Work Order ID 129681

Item Name: Quick Release Basket Mounting Spacepod™ & Squirrel Cheek Fits LH or RH

DART SERVICE INSTRUCTION

TO AMEND INSTALLATION INSTRUCTIONS D350-607-3 Rev.D,
INSTALLATION INSTRUCTIONS D350-607-4 Rev. C AND
INSTRUCTIONS FOR CONTINUED AIRWORTHINESS ICA-D350-607 REV. 6
REF TCCA STC: SH94-14
REF FAA STC: SR00213NY
REF EASA STC: EASA.10016996
REF BRAZILIAN STC: 2007S03-03/-04/-05/-06

FIGURE 1: INSTALLATION OF D4775-041 FWD STRUT

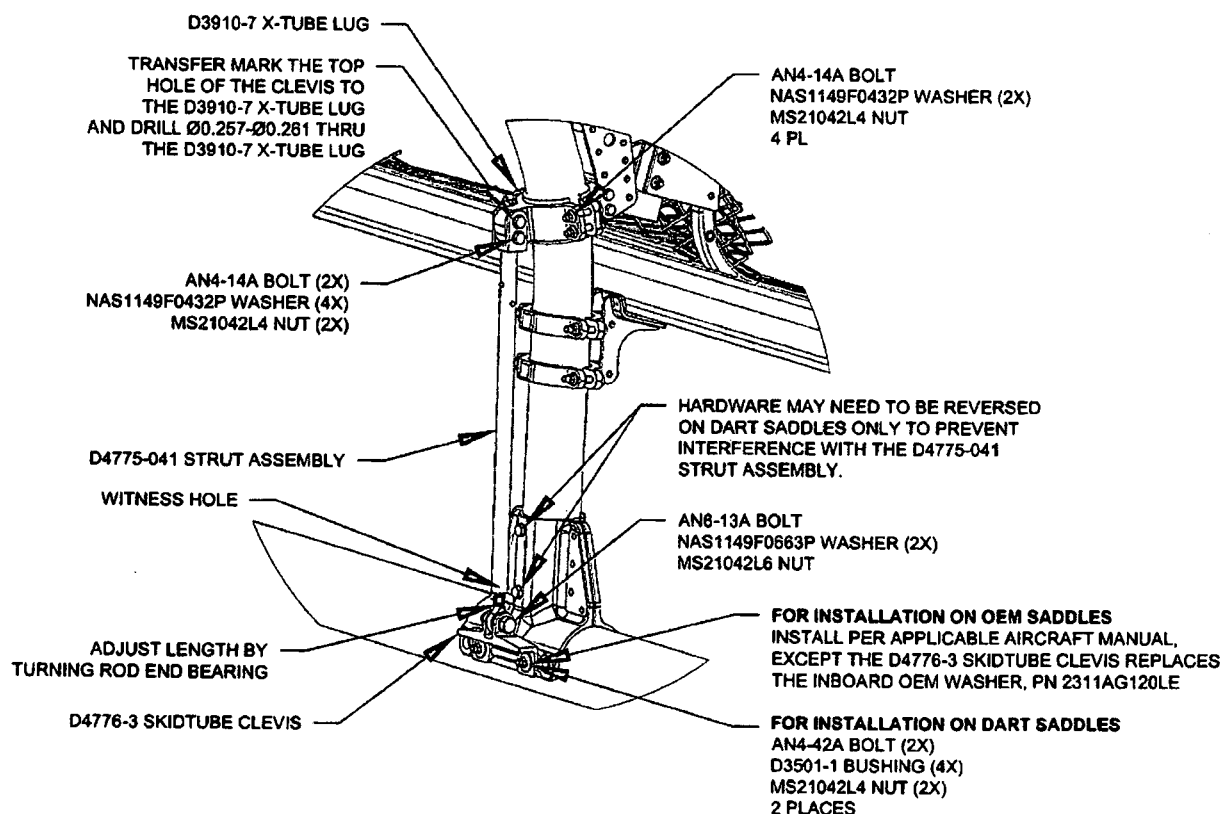
- 3.1 Substitute the Forward Lower D3910-5 X-Tube Lug with the D3910-7 X-Tube Lug as shown in Figure 1.
- 3.2 Install the forward D4775-041 Strut Assembly. Transfer mark from the upper hole on the clevis of the D4775-041 Strut Assembly to the D3910-7 X-tube Lug and drill thru the lug $\varnothing 0.257$ - $\varnothing 0.261$ as shown in Figure 1. Touch up chemical conversion coating per MIL-DTL-5541. Check the witness holes located at the bottom end of the D4775-041 Strut Assemblies to ensure that the thread from the rod end extends past the witness hole.
Torque MS21042L4/-4 nuts to 50-70 in-lbs (5.7-7.9 N-m). Torque MS21042L6/-6 nuts to 160-190 in-lbs (18.1-21.5 N-m).
- 3.3 Complete the installation in accordance with Installation Instructions D350-607-3 Rev. D or D350-607-4 Rev. C.
